UNITED STATES PATENT AND TRADEMARK OFFICE

APPLICATION NO.	FILING DATE	FIRST NAMED INVENTOR	ATTORNEY DOCKET NO.	CONFIRMATION NO.
10/786,918	02/25/2004	Jean-Yves Coillard-Lavirotte	52022/TJD/M881	4980

Office Action Summary	Application No. 10/786,918	Applicant(s) COILLARD-LAVIROTTE ET AL.	
	Examiner Mary Hoffman	Art Unit 3733

DETAILED ACTION

FIG. 1

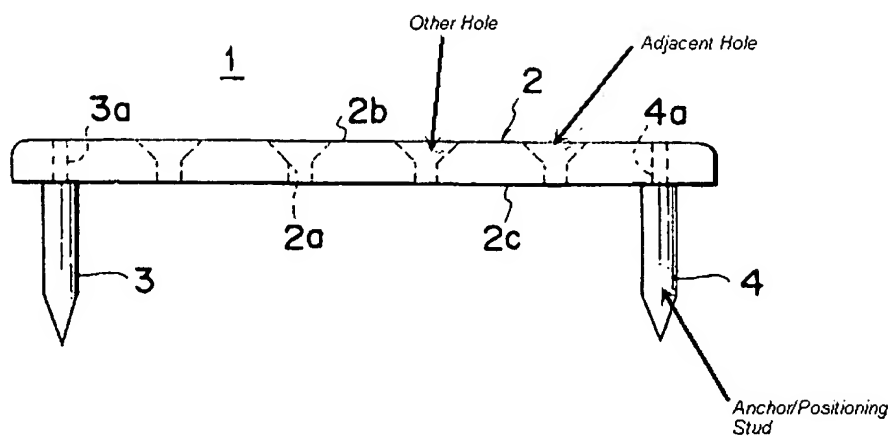
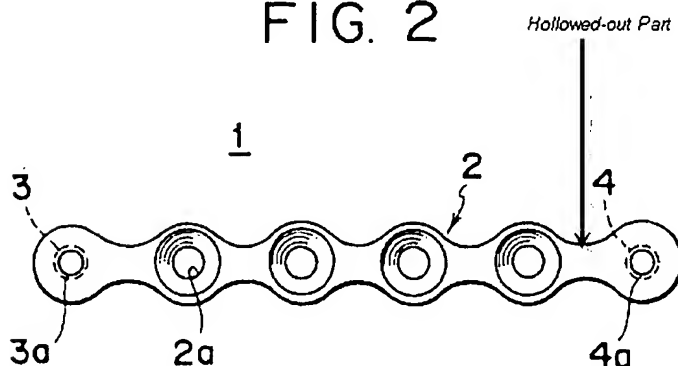
Maruyama et al. disclose a miniplate comprising an anchor and positioning stud (FIG. 1, ref. #4) at one of its ends approximately perpendicular to the miniplate and an adjacent hole (FIG. 1, ref. #2a) for an attachment screw, designed to cooperate with a widest proximal end of the phalange and secondly at least one other hole (ref. #2a) for an attachment screw in the said miniplate and designed to cooperate with a distal end of the same phalange, wherein the miniplate has an anatomic profile in its frontal plane (ref. #2b) and in its sagittal plane, wherein the frontal plane has a widened area to approximately cover the widest proximal end of the phalange, wherein the stud and the adjacent hole for an attachment screw are designed to cooperate with the widest proximal end of the phalange and are adapted to be positioned approximately on a same traverse axis (x, x') of the phalange for better use of the available surface in this widened area of the phalange and wherein the stud is separated from the hole intended for the adjacent attachment screw by a hollowed-out part (see FIG. 2, narrow part of plate 1 between hole ref. #2a and ref. #4) formed in the said anatomic miniplate between the said stud and the said attachment hole. The sagittal plane of the anatomic miniplate is significantly curved to match the corresponding profile of the phalange (col. 3, lines 64-end, and col. 4, lines 1-4). The anatomic miniplate forms a single-piece part. The anatomic miniplate is made from titanium (col. 3, line 55). The frontal and sagittal anatomic profiles of the anatomic mini-plate correspond to a right foot phalange or a left foot phalange respectively.

FIG. 5

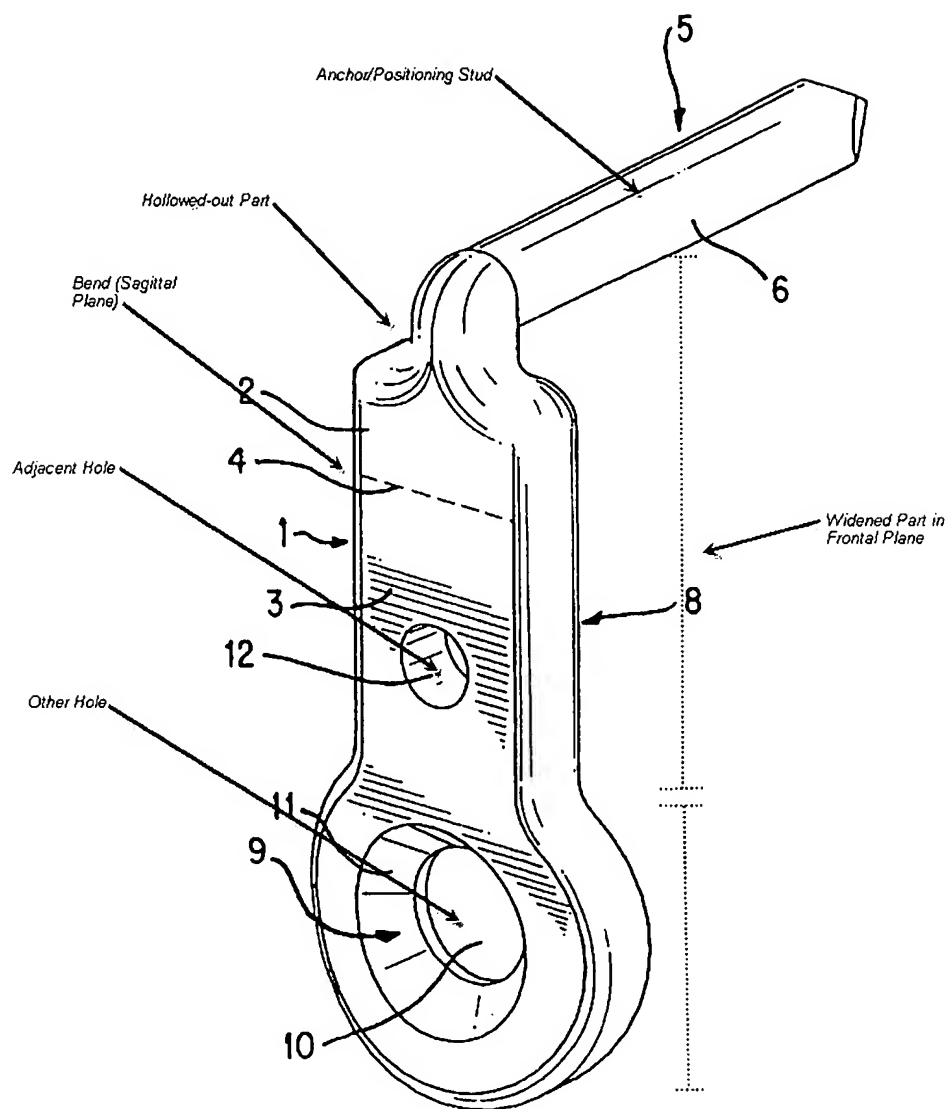
Mortier discloses a miniplate (see marked up figure below) comprising an anchor and positioning stud at one of its ends approximately perpendicular to the miniplate and an adjacent hole for an attachment screw, designed to cooperate with a widest proximal end of the phalange and secondly at least one other hole for an attachment screw in the

said miniplate and designed to cooperate with a distal end of the same phalange, wherein the miniplate has an anatomic profile in its frontal plane and in its sagittal plane, wherein the frontal plane has a widened area to approximately cover the widest proximal end of the phalange, wherein the stud and the adjacent hole for an attachment screw are designed to cooperate with the widest proximal end of the phalange and are adapted to be positioned approximately on a same traverse axis (x, x') of the phalange for better use of the available surface in this widened area of the phalange and wherein the stud is separated from the hole intended for the adjacent attachment screw by a hollowed-out part formed in the said anatomic miniplate between the said stud and the said attachment hole. The sagittal plane of the anatomic miniplate is significantly curved to match the corresponding profile of the phalange. The anatomic miniplate forms a single-piece part. The anatomic miniplate is made from stainless steel (col. 4, line 31). The frontal and sagittal anatomic profiles of the anatomic mini-plate correspond to a right foot phalange or a left foot phalange respectively.
